UNITED STATES OF AMERICA  
NUCLEAR REGULATORY COMMISSION

In the Matter of	)	
	)	Docket Nos. 50-445 and
TEXAS UTILITIES ELECTRIC	)	50-446
COMPANY, ET AL.	)	
	)	(Application for
(Comanche Peak Steam Electric	)	Operating Licenses)
Station, Units 1 and 2)	)

AFFIDAVIT OF D.N. CHAPMAN, J.C. FINNERAN, JR.,  
D.E. POWERS, R.P. DEUBLER, R.E. BALLARD, JR.  
AND A.T. PARKER REGARDING QUALITY ASSURANCE  
PROGRAM FOR DESIGN OF PIPING AND PIPE  
SUPPORTS FOR COMANCHE PEAK STEAM ELECTRIC STATION

SUPPORT NO. CH-2-215-704-523R  
SHEET 1 OF 1 REV. 0

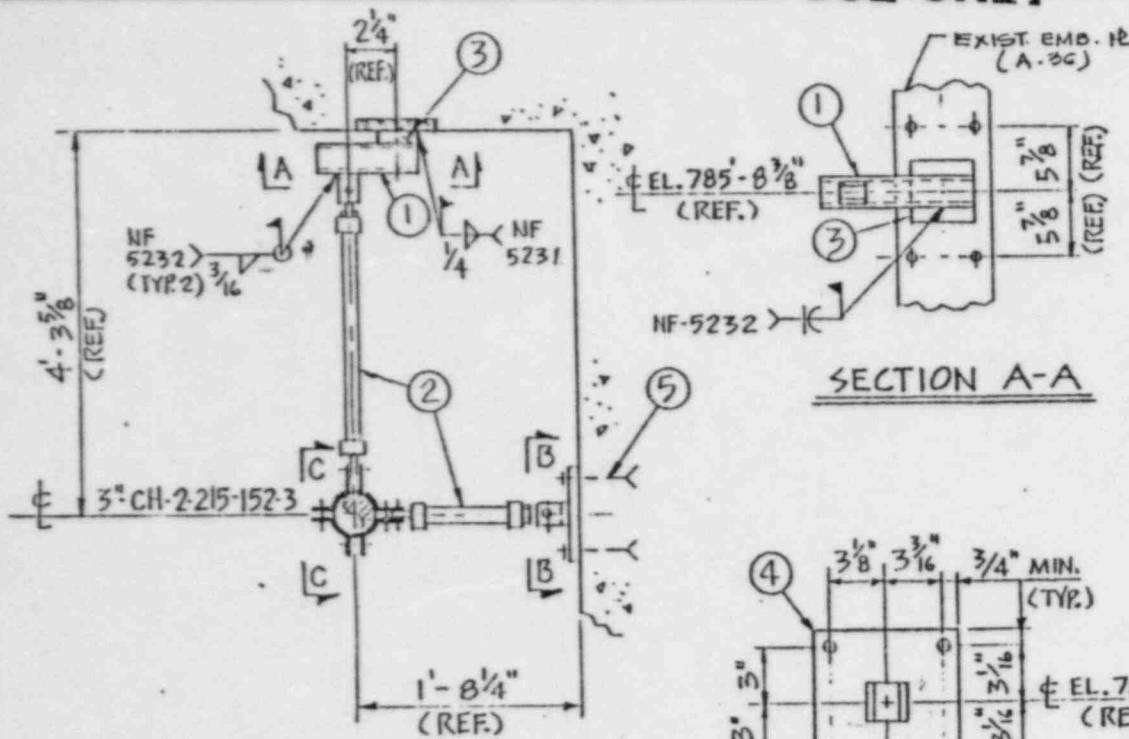
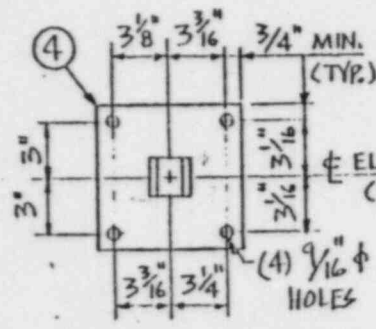
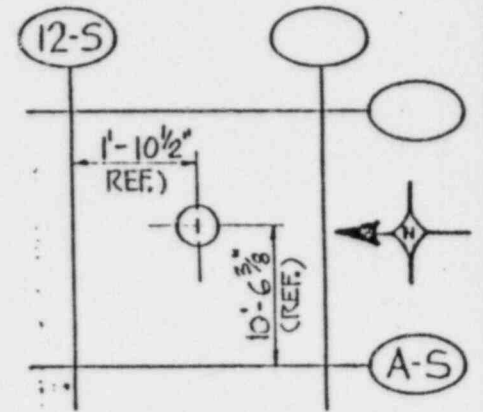
Two examples of corrective action being initiated as a result of action by persons using design documents are CMC No. 97241, Rev. 0 (against drawing CS-2-309-701-S33R) (PSE Attachment 4) and CMC No. 97423, Rev. I (against drawing CH-2-215-709-S23R) (PSE Attachment 5). The first CMC was initiated by a PSE field engineer in order to identify and correct a drawing on which no NF number had been given for the weld symbol. Another example involves an instance in which it was noted, again, by a PSE field engineer, that the site engineering organization had used an incorrect weld symbol on a drawing calling for a fillet weld where a fillet
